NL-10-061

SUBJECT: 10 CFR 50.55a Relief Requests RR-3-49 and RR-3-50 from Examinations of
Component Welds with Less Than Essentially 100 % Examination Coverage For
Third Ten-Year Inservice Inspection Interval
Indian Point Unit Number 3
Docket No. 50-286
License No. DPR-64

RELIEF REQUEST NO: RR-3-49

RELIEF REQUEST NO: RR-3-50

Welds 1-1300-2, 1-1300-3, 1-1300-4, 1-1300-5, 1-1300-6, and 1-1300-7

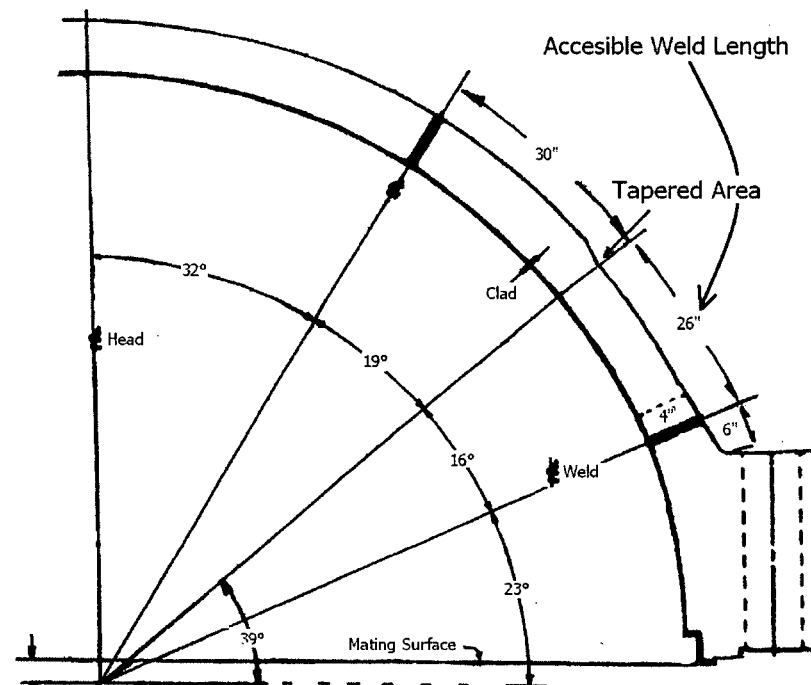
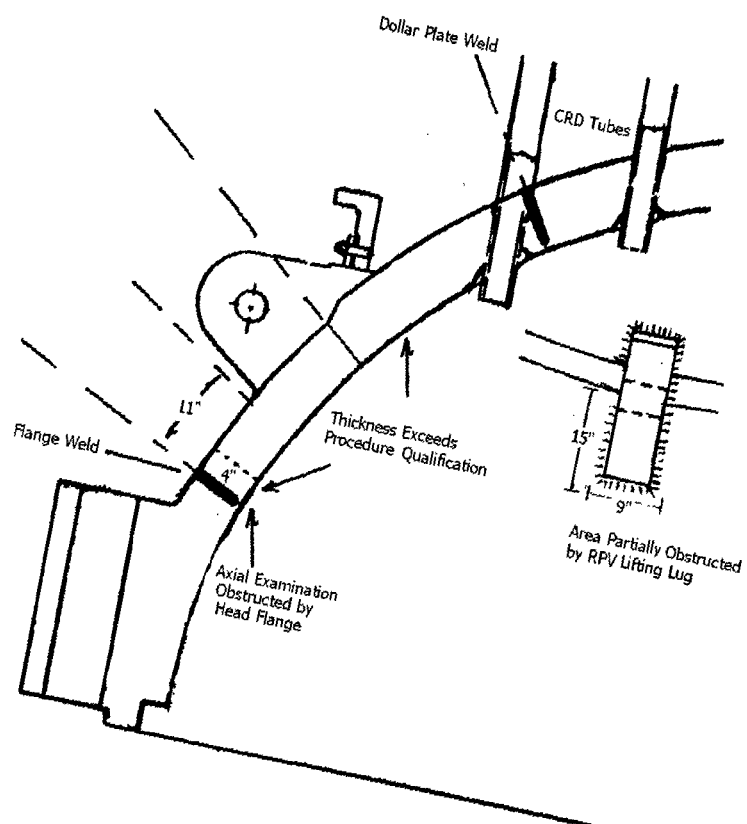
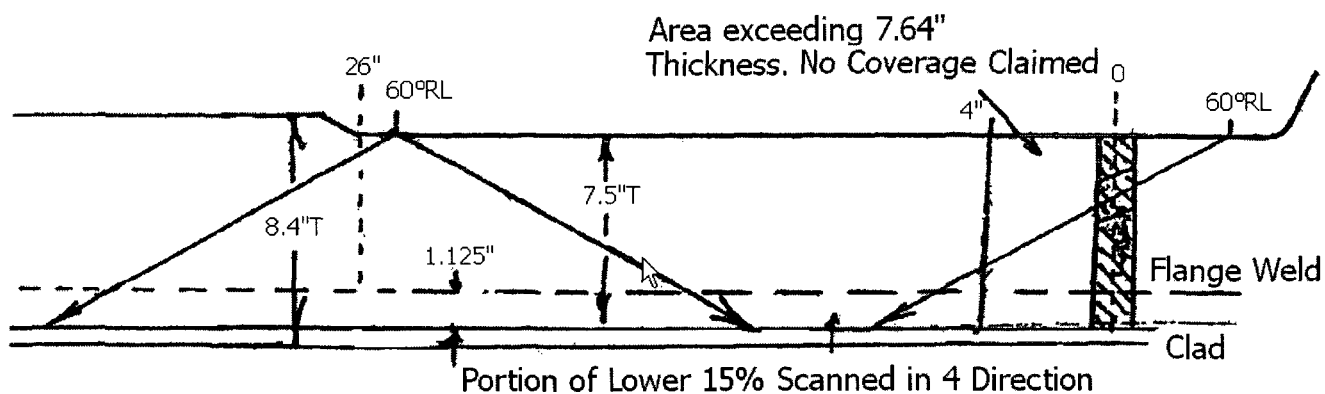
The Reactor Vessel (RV) Meridional Head welds are 56" long, with a total accessible weld length of 26". The Code Required Volume (CRV) was interrogated ultrasonically using personnel and procedures qualified in accordance with ASME Section XI, Appendix VIII, Supplements 4 and 6 (Performance Demonstration Initiative (PDI)). Code coverage of the CRV was only credited for those areas that were examined in accordance with the qualified procedure. The ASME Section XI Code Requirement is to examine essentially 100% of the weld.

The accessible length of the welds were scanned with the transducer oriented perpendicular to the weld centerline in two (2) directions using a 60 degree refracted longitudinal (RL) transducer, which resulted in 100% coverage of the CRV for that scan direction. The welds were also scanned with the transducer oriented parallel to the weld. The welds are tapered adjacent to the head flange for approximately four (4) inches of the weld, where the material thickness exceeds the maximum range for the qualified procedure, 7.64" thickness. The tapered areas were examined; however Code coverage was not credited in those areas.

The scan parallel to the welds was limited due to the RV head flange at one end of the weld and a taper on the other end of the weld. These physical limitations resulted in approximately 84% coverage, which is less than the required coverage of the CRV.

The Reactor Vessel (RV) Meridional Head welds are 56" long, with a total accessible weld length of 26". The Code Required Volume (CRV) was interrogated ultrasonically using personnel and procedures qualified in accordance with ASME Section XI, Appendix VIII, Supplements 4 and 6 (Performance Demonstration Initiative (PDI)). Code coverage of the CRV was only credited for those areas that were examined in accordance with the qualified procedure. The ASME Section XI Code Requirement is to examine essentially 100% of the weld.

The accessible length of the welds were scanned with the transducer oriented perpendicular to the weld centerline in two (2) directions using a 60 degree refracted longitudinal (RL) transducer. The welds were also scanned with the transducer oriented parallel to the weld. The welds are tapered adjacent to the head flange for approximately four (4) inches of the weld, where the material thickness exceeds the maximum range for the qualified procedure, 7.64" thickness. The tapered areas were examined; however Code coverage was not credited in those areas. These 3 welds also have the RV head lifting lugs located directly on top of the welds further restricting the examination in those areas.

The scan parallel to the welds was limited due to the RV head flange at one end of the weld, the RV head lifting lugs, and a taper on the other end of the weld. The scan perpendicular to the welds was limited due to the RV head lifting lugs. These physical limitations resulted in approximately 59% coverage, which is less than the required coverage of the CRV.

Weld 1-4401-12

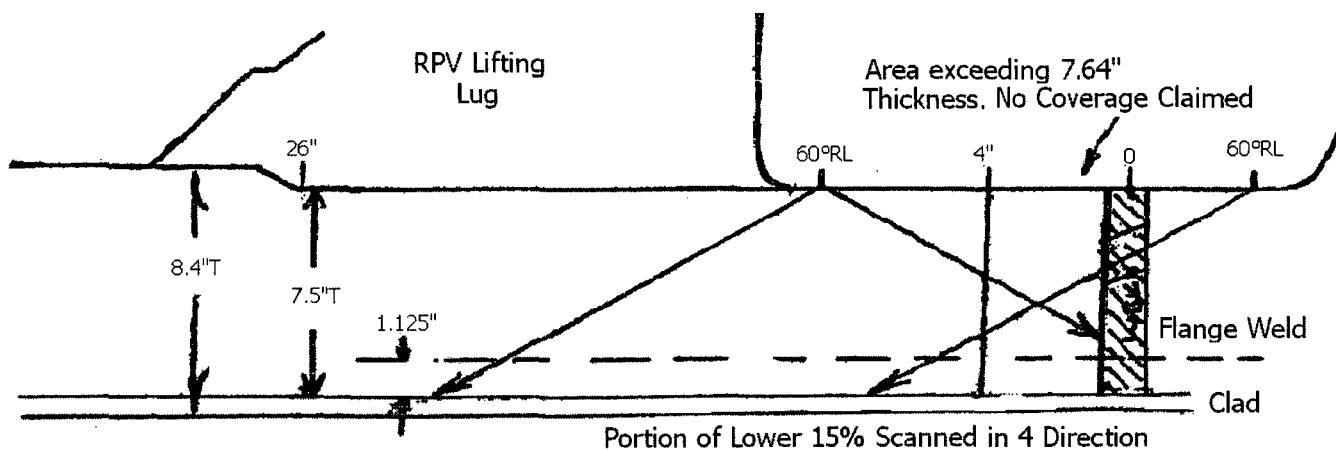
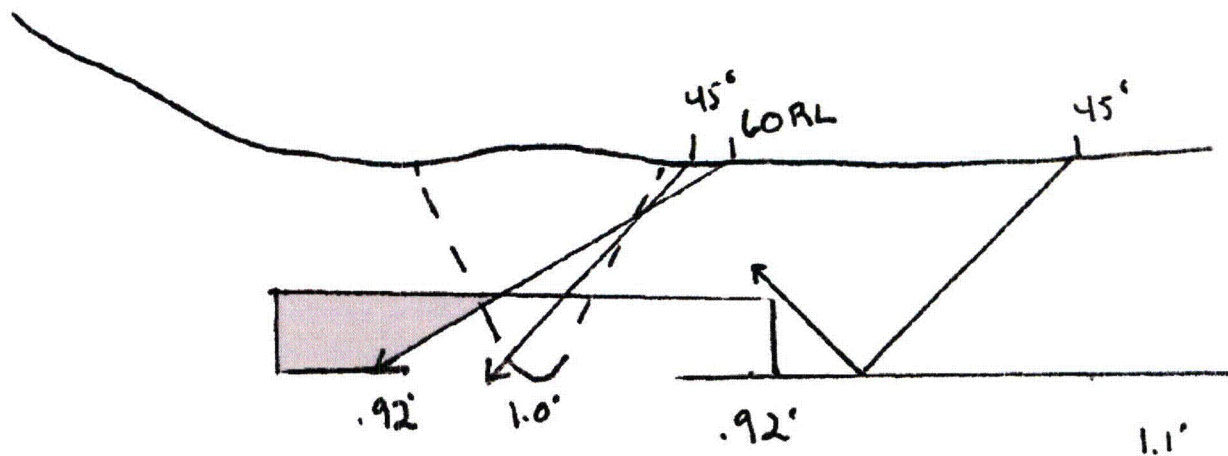
Welds 1-4401-12 and 1-4301-12 are nozzle to elbow welds with no inspection able to be performed from the nozzle side due to component geometry. This physical limitation resulted in approximately 50% coverage, which is less than the required coverage of the CRV. Weld 1-4301-4 is a tee to elbow weld with a limited inspection able to be performed from the tee side due to component geometry. This physical limitation resulted in approximately 65% coverage, which is less than the required coverage of the CRV.

Risk Informed Piping Welds; 1-4100-15, 1-4200-15, 1-4300-15, 1-4400-15

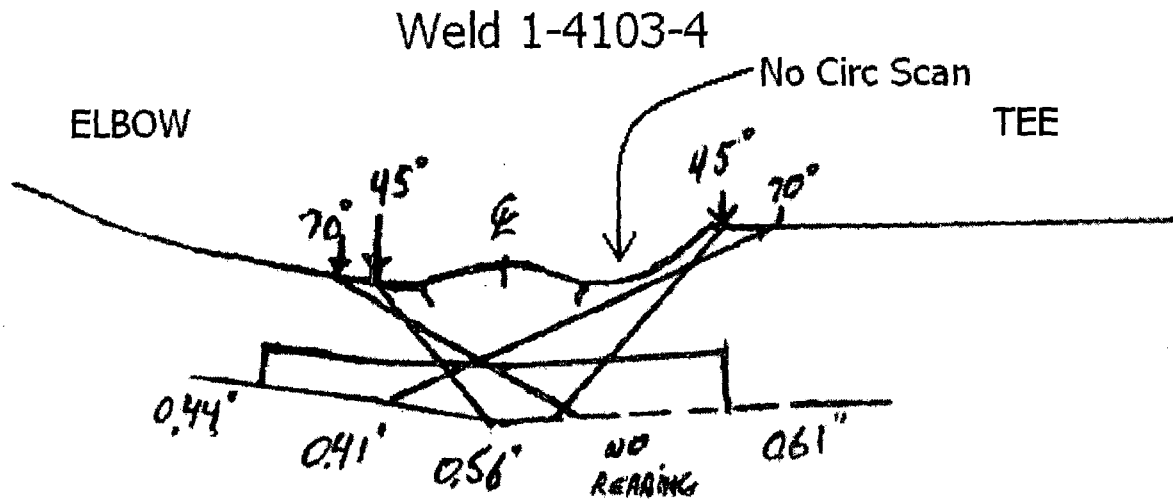
On the Reactor Vessel inlet nozzles, a cast stainless steel (A351 Grade CF8M) elbow is welded to the safe-end upstream of the dissimilar metal weld (welds 1-4100-15, 1-4200-15, 1-4300-15, 1-4400-15). There are currently no Appendix VIII (PDI) qualified procedures to inspect cast stainless steel materials. The entire volume was examined employing the Appendix VIII procedure qualified for the examination of austenitic welds. Examinations conducted using this procedure met or exceeded the required Appendix III examinations. The discussion below is to help describe the logic and methodology used in calculating the exam coverage estimates.

Code required examination volume that was scanned is estimated at greater than 96%. This documents the code required examination volume that was scanned utilizing both a PDI qualified technique and the use of the PDI qualified procedure for areas where there is no PDI qualified procedures (i.e. the cast elbows). This coverage calculation considers all four required examination beam directions and shows that greater than 96% of the code required examination volume was scanned on all 4 welds. The only limitations to scanning were due to ID surface condition configurations.

When disallowing examination into or from the cast material, coverage of the code required volume is estimated at 45% (Reference attached Figure 1). As can be seen from Figure 1, the limited coverage area includes any area which requires the sound to pass thru the cast stainless steel material. In the case of the axial scan from the cast side shown in Figure 1, this means no coverage is credited until the sound path travels from the transducer, thru the clad, directly into the weld, and then into the base metal of the safe-end. The same logic is applied for the axial scan from the safe-end side and the circ scans.

RHR Heat Exchanger Shell Circumferential Weld; 2-1120-31-2 (Profiles)

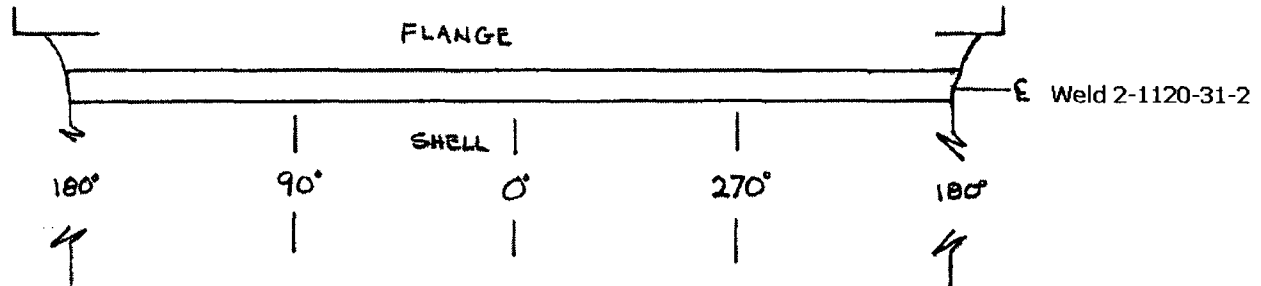
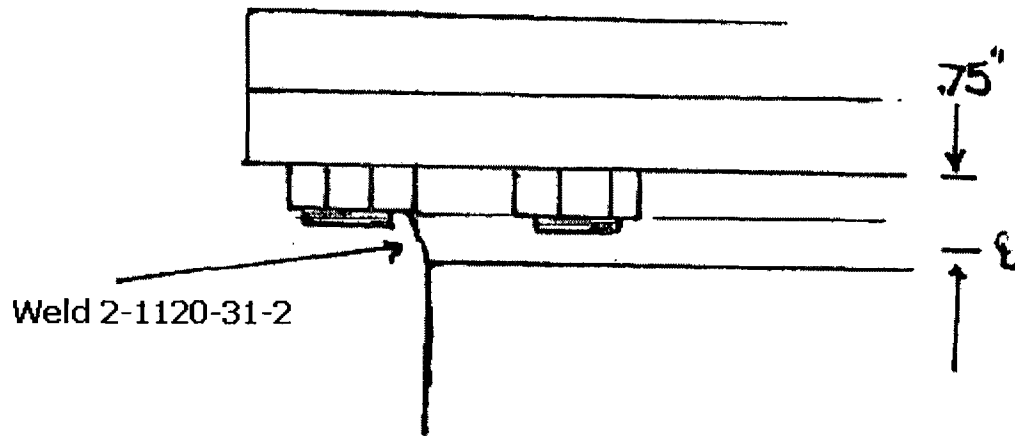
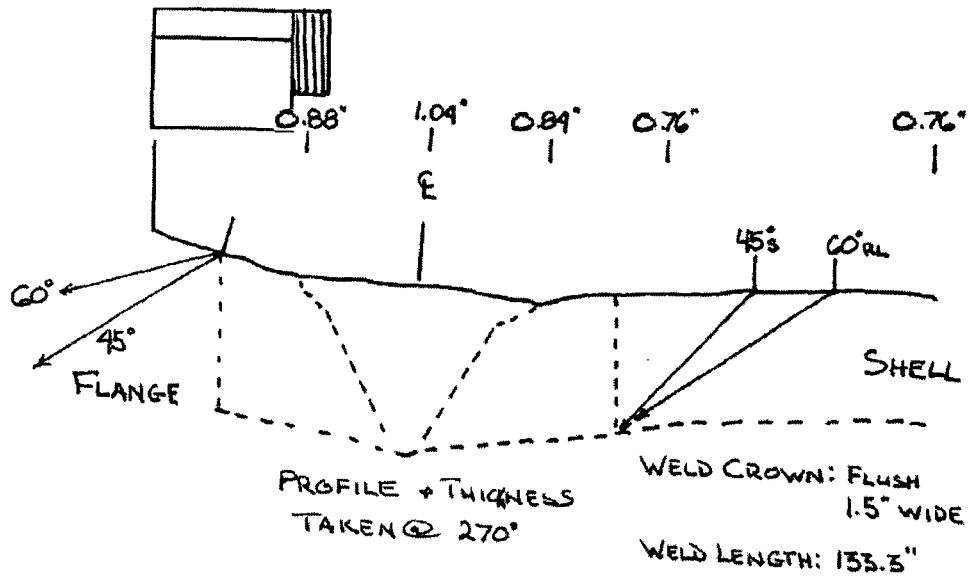
The Residual Heat Removal (RHR) Heat Exchanger Shell circumferential weld 31-2 is 133" long and attaches the heat exchanger shell to a flange. The Code Required Volume (CRV) was interrogated ultrasonically using personnel and procedures in accordance with ASME Section XI. Code coverage of the CRV was only credited for those areas that were examined in accordance with the procedure requirements. The ASME Section XI Code Requirement is to examine essentially 100% of the weld.

Due to the proximity of the heat exchanger flange to weld 31-2, the weld could not be scanned from the flange side. This physical limitation resulted in approximately 75% coverage, which is less than the required coverage of the Code Required Volume.

Weld 2-2532-6

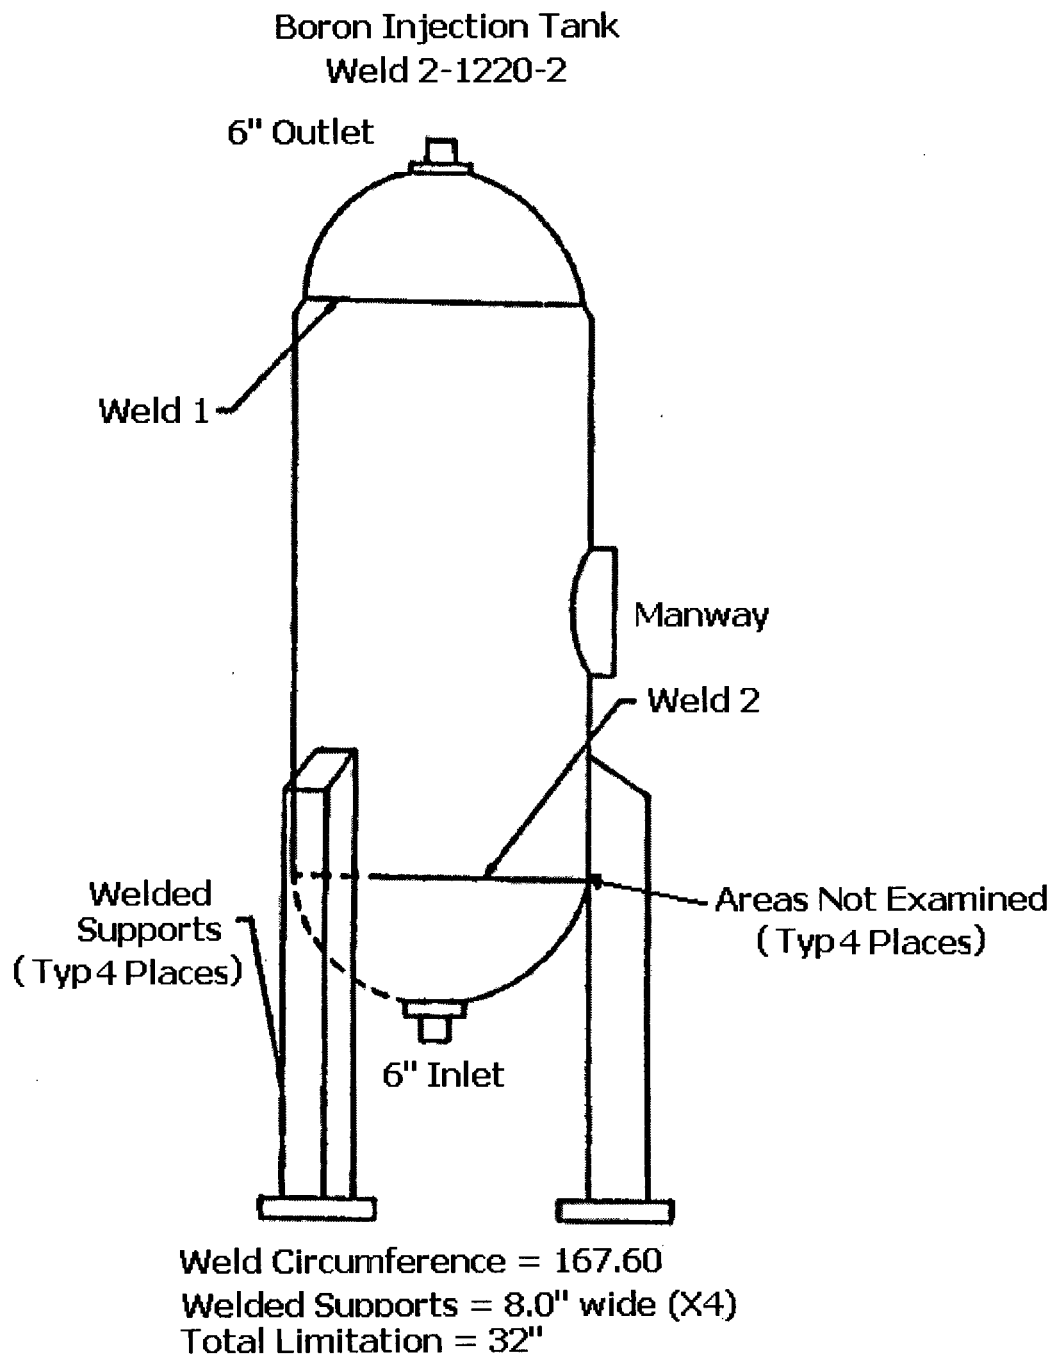
Weld 2-2532-6 is a flange to pipe weld and it is not possible to perform the ultrasonic examination from both sides of the weld since one side of the weld was not suitable for scanning due to the OD surface geometry of the component (flange). Therefore, the weld only received a single sided examination resulting in less than 90% coverage of the required examination volume. This physical limitation resulted in approximately 75% coverage, which is less than the required coverage of the CRV.
